**BELL BEND NUCLEAR POWER PLANT
BBNPP PLOT PLAN CHANGE
COLA SUPPLEMENT, PART 3 (ER);
SECTION 4.4 AND REVISED RESPONSES TO
ER RAIs SE 4.4-1, SE 4.4-2 & SE 4.4-10
BNP-2010-319 Docket No. 52-039**

Revised BBNPP COLA Part 3 (ER), Section 4.4, Revision 2b

Revised responses to Requests for Additional Information
SE 4.4-1, SE 4.4-2, and SE 4.4-10

Figure 4.4-1— BBNPP Traffic Impact Assessment Study Area

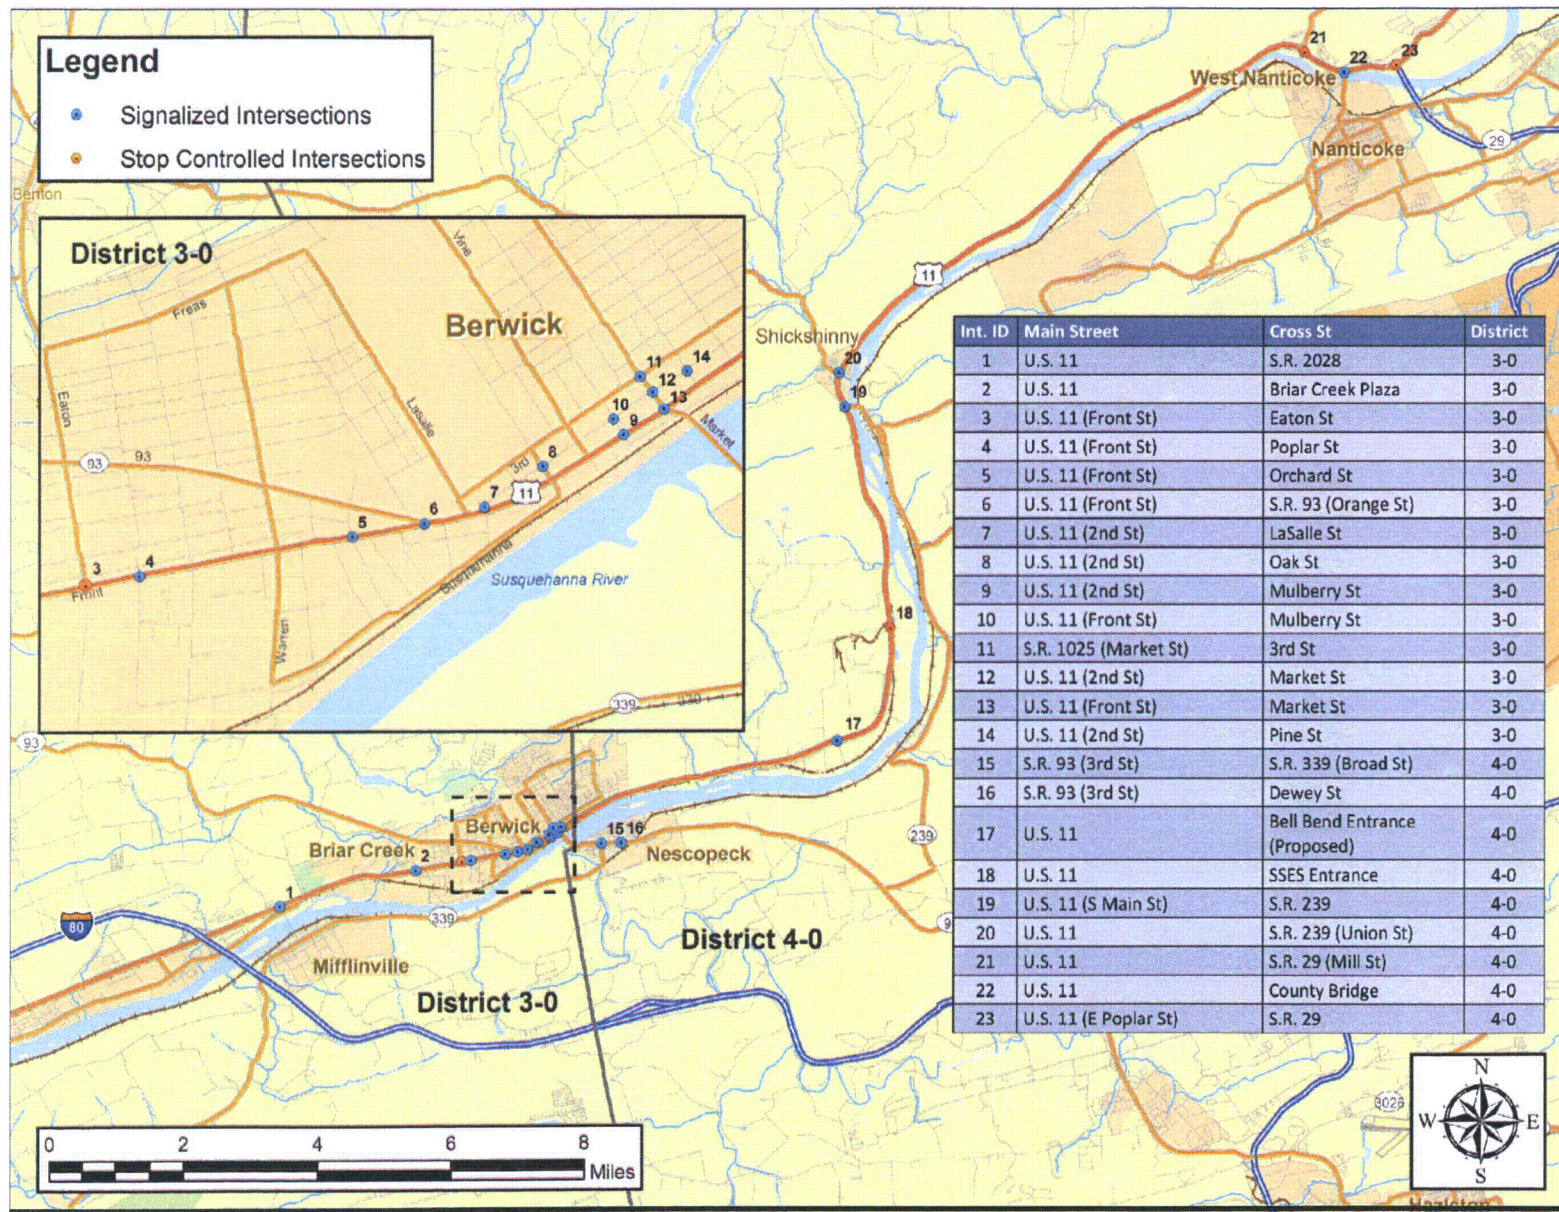
Summary: *Revise text identifying the local network as sufficient to reflect the results of the traffic study by KLD, "Traffic Impact Study Related to the Proposed Construction and Operation of the Bell Bend Nuclear Power Plant, Preliminary Findings Report."*

Full Text: RAI SE4.4-2 presents more detail regarding the issue being raised here. In addition, local officials documented potential issues with the transportation network during the recent site visit and also mentioned that trucks delivering materials during construction might be too large to safely make the turn from Route 11 off Route 93, and that these vehicles may need to be diverted down Route 29 to Danico before turning left onto Route 11. Further, there is no light at the intersection of Route 29 and Route 11 but one may be needed to accommodate more heavy trucks.

Response: The traffic study referred to in the RAI SE 4.4-1 Question Summary is cited in the text of ER Section 4.4.1 and was revised in August 2010, to include a larger traffic study area. The study identified that during the construction phase, mitigation, mostly signaling, will be required to maintain an adequate level of service (LOS) at key intersections. As a result, the existing wording is appropriate given that mitigation will be required. Attached to this RAI response are Table 29 and text excerpts from the revised KLD report which identify the specific mitigation measures that might be proposed to support construction and operations related traffic. Mitigation measures were revised as part of the 2010 update to the KLD study. Note that the KLD study refers to U.S Route 11 as S.R. (State Route) 11. This error has been identified and will be incorporated into a future revision of the KLD study.

With regard to the intersection of Route 11 and Route 29, requirements for traffic signals need to be determined based on the Traffic Signal Warrants as defined in the MUTCD [2007] and discussed with PennDOT District 4-0. The volume of trucks being added will not alone be sufficient to invoke one or more of the MUTCD warrants.
